Access Compliance Report

Public Rights-of-Way

(Curb Ramps)

Intersection ID: 48138	Main Street: BEATY_CALDWELL_LN	Cross Street: MCCAMEY_DR	Location: NW
ADA ID: 899AC4E3B277	Ramp Type: PerpDiag	Initial Pass/Fail: Fail	Overall Compliance: No
Severity Score: 8.75			
Codes/Mitigation Info/Possible Solution		Field Measurements/Component Compliance

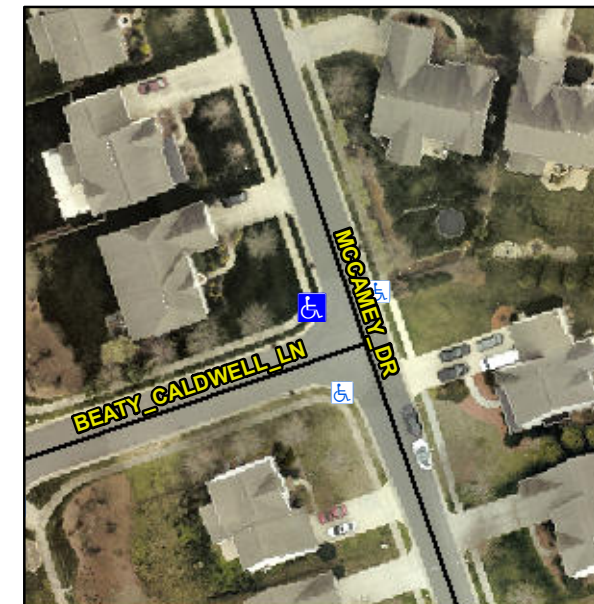
Not Found, R304.5.1

Compliance	Description	Data	Compliance	Description	Data
N/A	Ramp Length (in)	48.0	Yes	Ramp Slope (%)	5.0
No	Ramp Width (in)	47.0	Yes	Ramp XSlope (%)	0.6
N/A	Flare Type LT	N/A	N/A	Flare Type RT	N/A
N/A	Flare Slope LT (%)	N/A	N/A	Flare Slope RT (%)	N/A
N/A	Flare Traversable LT?	N/A	N/A	Flare Traversable RT?	N/A
N/A	Landing Length (in)	N/A	N/A	DWS Provided?	N/A
N/A	Landing Width (in)	N/A	N/A	DWS Contrast?	N/A
N/A	Landing Slope (%)	N/A	N/A	DWS Length (in)	N/A
N/A	Landing X Slope (%)	N/A	N/A	DWS Full Width?	N/A
N/A	Landing Curb? (Y/N)	N/A	N/A	DWS Offset (in)	N/A
N/A	Shared Landing?	N/A			
N/A	Gutter Ponding?	N/A	N/A	Gutter Slope (%)	N/A
N/A	Gutter Lip Ht (in)	N/A	N/A	Gutter X Slope (%)	N/A
N/A	Painted X Walk1?	No	N/A	Painted X Walk2?	No
	X Walk 1 Direction	To S		X Walk 2 Direction	To E
N/A	X Walk 1 Width (in)	N/A	N/A	X Walk 2 Width (in)	N/A
	X Walk 1 Slope (%)	1.0		X Walk 2 Slope (%)	2.0
	X Walk 1 X Slope (%)	0.2		X Walk 2 X Slope (%)	0.8

Remove & Replace Curb Ramp With Two New Directional Ramps or Equivalent.
